COMMENTS FOR VALLCO SHOPPING DISTRICT SPECIFIC PLAN DEIR

Draft Environmental Impact Report SCH# 2018022021

JUNE 6, 2018

Figure 4: DEIR Heights

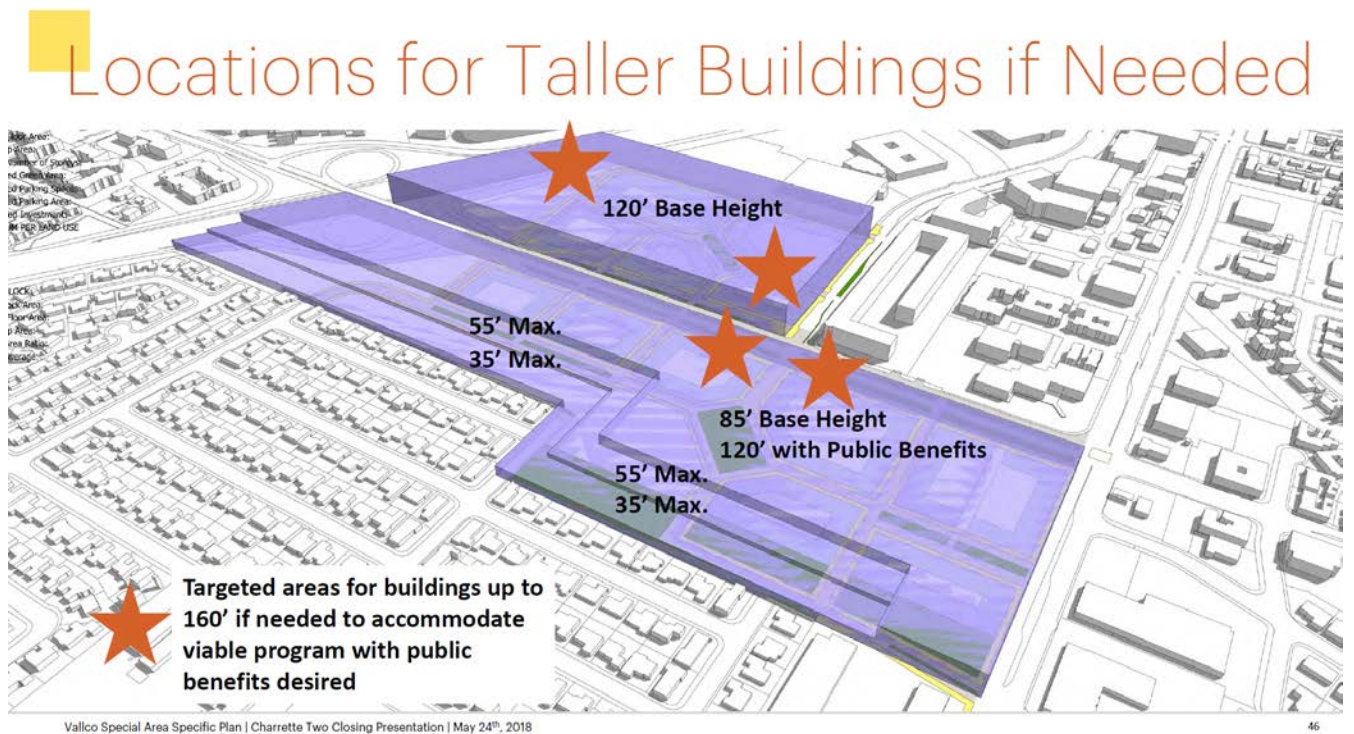
4. To add to the confusion as to what the project may end up being, the maximum height was also shown to be 294'. These height differences will cause different shadow and intrusion issues, such as privacy intrusion into Apple Campus HQ which may be a security risk at the corporate headquarters, guest discomfort at the outdoor swimming pool at Hyatt House, and the lack of privacy for the area homes and back yards. In Section 4.2.1 of the DEIR, heights are shown up to 165'.

Figure 10: Section from SB 35 Vallco Application

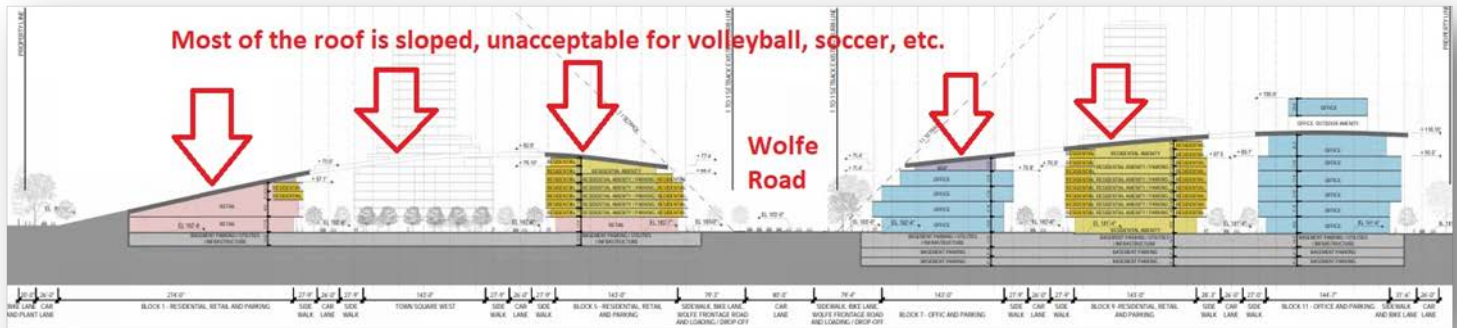
The 30 acre green roof is not park land acreage per the Municipal Code. While it may be considered a recreational area, the uses of such space are limited. Here is a cross section of the SB 35 plan roof:

Figure 25: AQI from BAAQMD

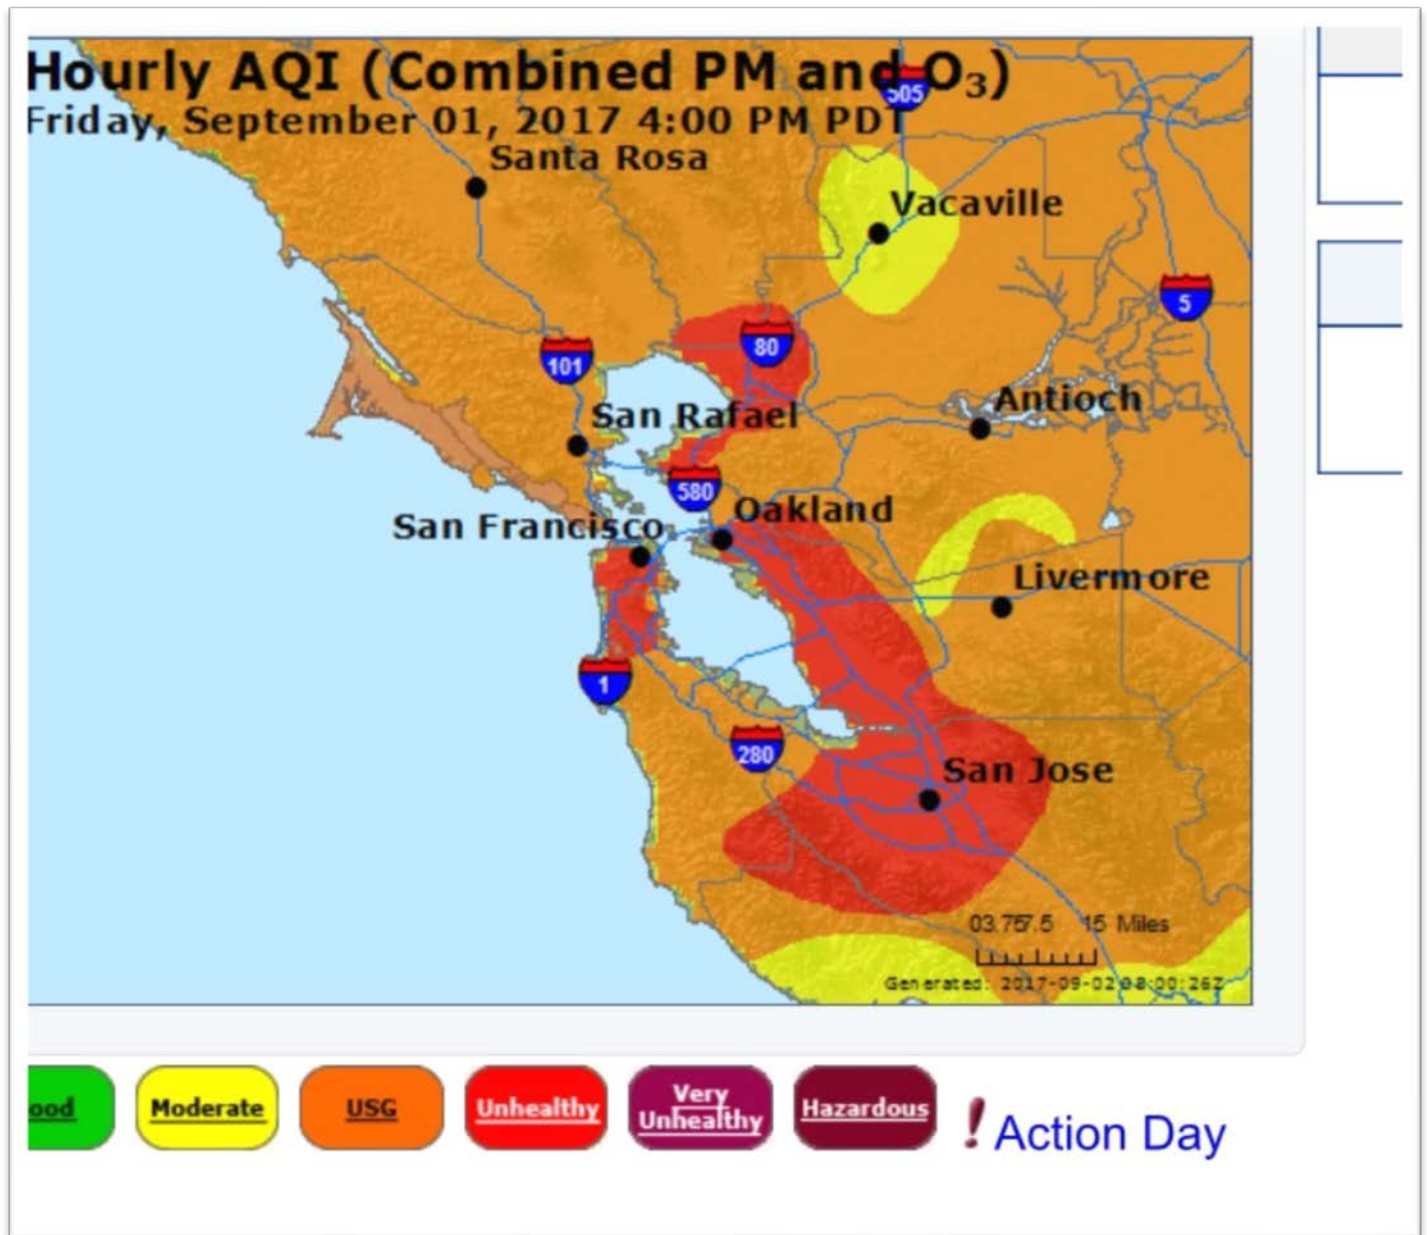
The cancer risk assessment is based on erroneous traffic studies and the air quality monitoring stations had old data from 2013 and/or were too far away to use data. The cancer risk needs to be recalculated. The amount of exposure time should reflect seniors not leaving the project area. The baseline air quality monitoring must be taken over an extended period with particular attention paid to the summer months when Ozone levels increase. Here is an example day when children would be playing outdoors, Ozone was the primary pollutant. Note these are regional amounts, and the increases along the freeways are not shown:

The I-280 freeway produces substantial TAC pollutant concentrations and the south bay is subjected to the entire bay area's pollutants which are converted to Ozone in the warm summer months. The DEIR failed to monitor air pollution for the site for any time period, and only modeled pollutants onsite. Fires are expected to be the new normal, bringing potential further impacts to the region's air quality.

Figure 42: Opticos Charrette #2

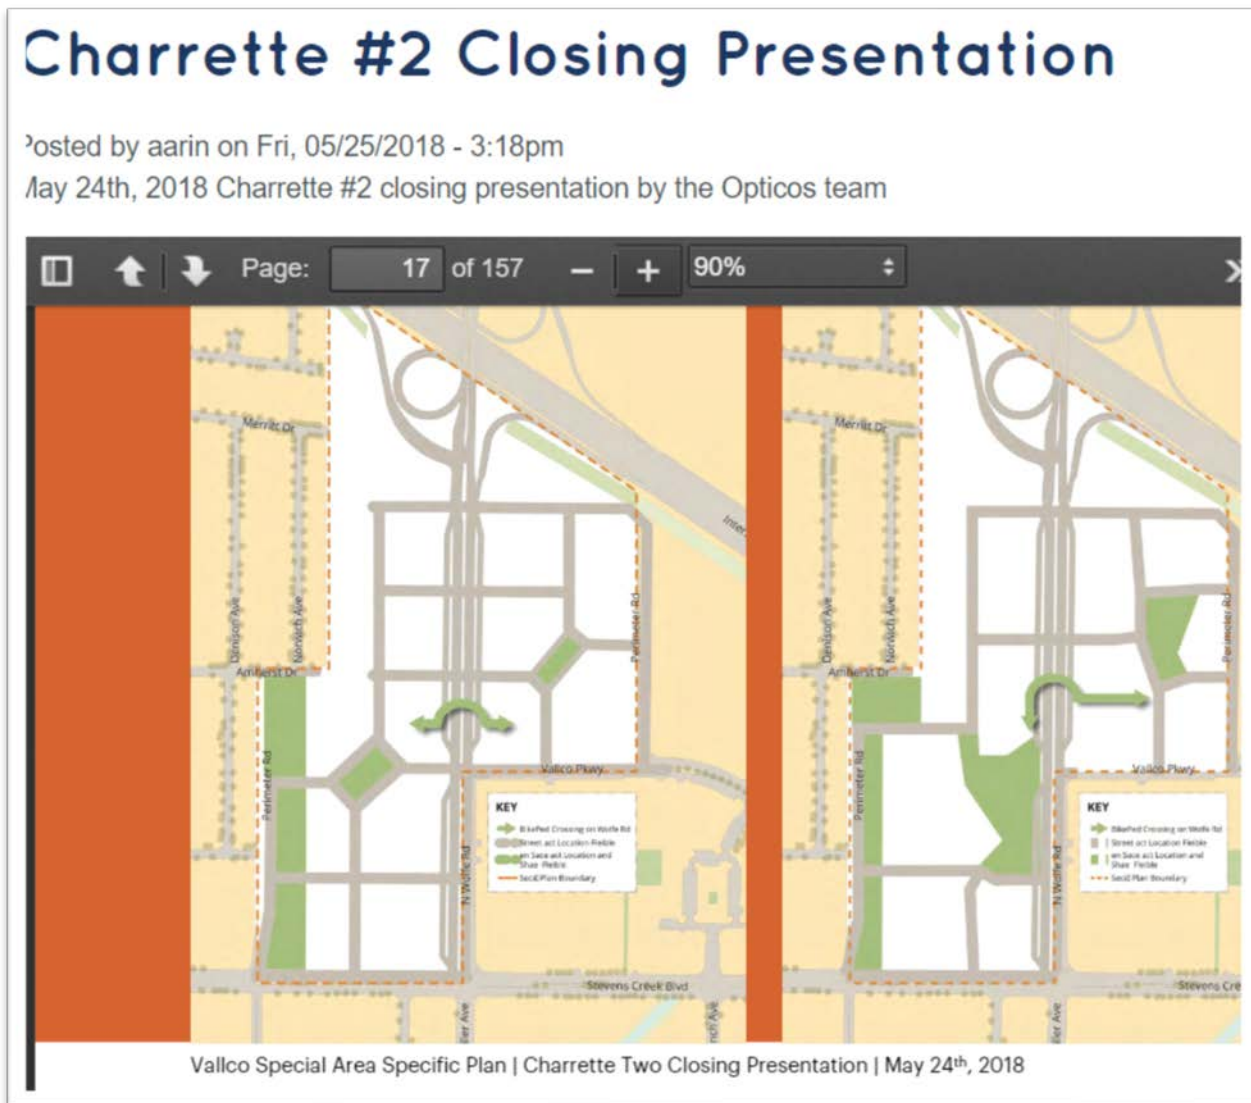
Charrette #2 Closing Presentation shows parks adjacent to back yards of single family residences. This may, combined with Perimeter Rd. noise exceed Municipal Code permissible sound levels. The DEIR does not adequately address this.

FIGURE 3.13-2

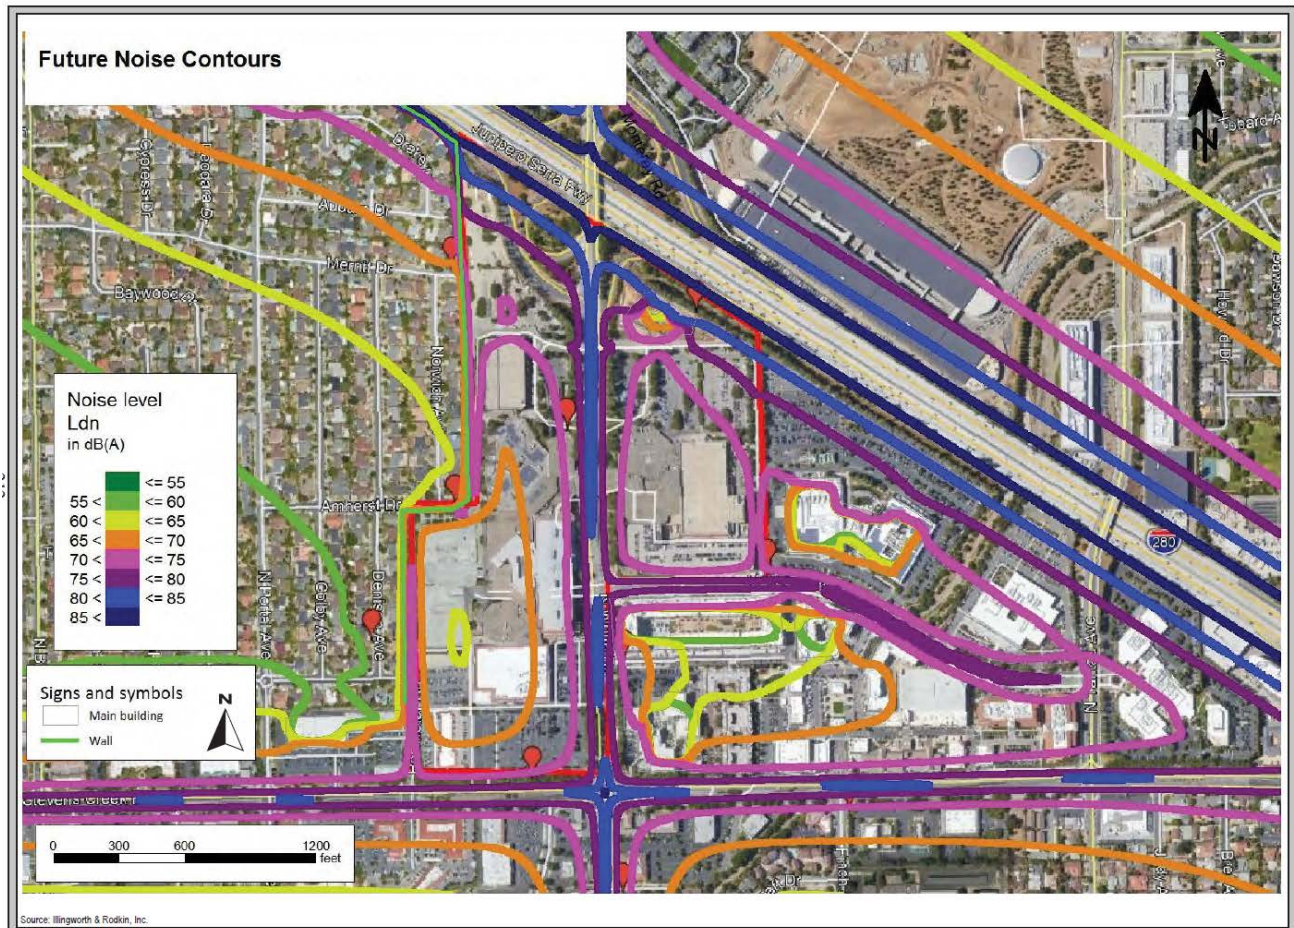
The Future Noise Contours map has some omissions regarding noise from the Perimeter Road, western edge park, and proposed amphitheater. The map has gross assumptions regarding what the plan would look like and ignores conditions on the roof which would result in a separate layer of mapping: One layer for ground level (ear level) and one level for the roof park to see if it meets park noise requirements.

The future noise contours for the project site exceed residential maximum levels according to the Cupertino Municipal Code 10.48.040.
